RE: Questa Tailing Facility – Phase 2 Building Demolition and Cleanup Plan Addendum No. 1 – Soil Removal at the Old Maintenance Shop

Questa Decommissioning and Demolition Project Building Demolition and Cleanup Plan Phase 2 Activities – Tailing Facility Area

Addendum No. 1 - Soil Removal at the Old Maintenance Shop

Figure 1 – Old Maintenance Shop Proposed Soil Removal

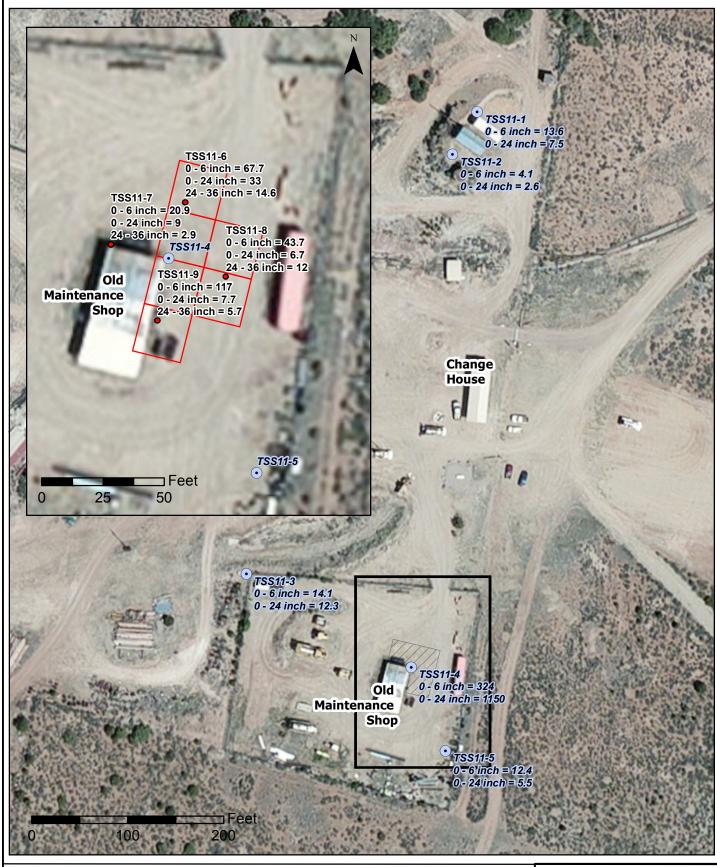
Shallow soil sampling was performed as part of the Comprehensive Environmental Response, Compensation, and Liability Act (CERCLA) Remedial Investigation at the tailing facility (URS 2009). One location, TSS11-4 – located near the Shop, was found to have elevated molybdenum concentrations in soil (Figure 1). In January 2015, the area around TSS11-4 was further characterized to determine the extent and depth of molybdenum in soil near the Shop (ARCADIS 2015). Results of the January 2015 sampling revealed three locations with molybdenum concentrations above the CERCLA soil preliminary remediation goal (PRG) of 41 milligrams per kilogram (mg/kg). Soil results from this sampling, combined with the TSS11-4 sample result, also show that molybdenum is constrained to the upper 6 inches of the ground surface. Subsurface samples were also collected from 0 to 24 inches and from 24 to 36 inches; subsurface samples were below the molybdenum PRG.

Removal of affected soils will be completed near the Shop (Figure 1). The initial soil excavation area will consist of six 20-foot by 20-foot grid cells totaling approximately 2,400 square feet. Each grid cell will be excavated to 12 inches deep, resulting in a total removal volume of approximately 90 cubic yards.

To confirm that molybdenum content in soil is below the 41 mg/kg PRG, each 20-foot by 20-foot grid cell will be sampled after excavation using a field X-ray fluorescence (XRF) analyzer. The XRF will be used to confirm the extent of molybdenum in shallow soils and to provide confirmation that affected soils have been removed. Five in-situ measurements will be taken – one from the floor of each grid cell and one from each sidewall of the excavation; if the average value of measurements is below the PRG, then the grid cell will be considered suitable for backfilling with clean soil. If the average value of the measurements is above the PRG, an additional 6 inches of material will be removed. The XRF measurements and excavation will continue until soils are below the PRG.

Confirmation sampling of the final excavation will be performed. Five samples will be collected, one from each of the north, south, east, and west sidewalls, and one from the bottom. Soil samples will be placed in a clean polyethylene bag and submitted for laboratory analysis. The samples will also be re-analyzed
